NUMBER: SB 550-80-001, Rev A
MODEL: ECLIPSE 550[®]
SUBJECT: Starter Generator TSO Label Correction

Mandatory
www.ECLIPSE.aero

Figure 1. S/G Data Plate

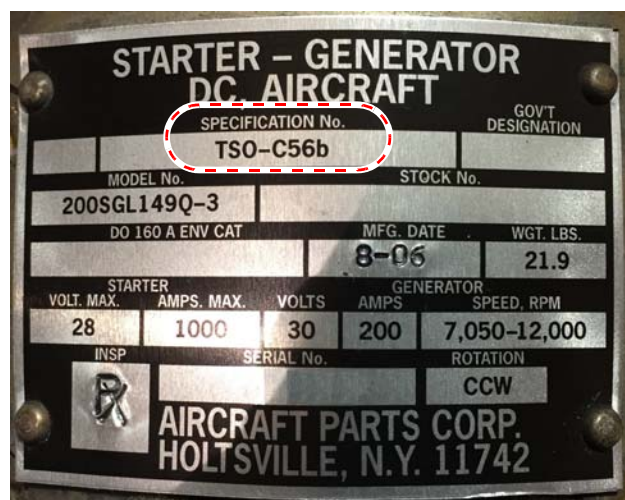
This bulletin removes the TSO specification number from the Starter Generator data plate.

This bulletin removes the TSO specification number from Starter Generator's that were mistakenly marked as having a TSO in accordance with part 45.15(2)(b).

- (1) Using best shop practice, abrasively remove "TSO-C56b" Ink/Paint marking from the SPECIFICATION No. area of the data plate.
- (2) Apply a chemical conversion coating to the cleaned area. Refer to AMM-20-09-00-051-801 – Aircraft Finishes.
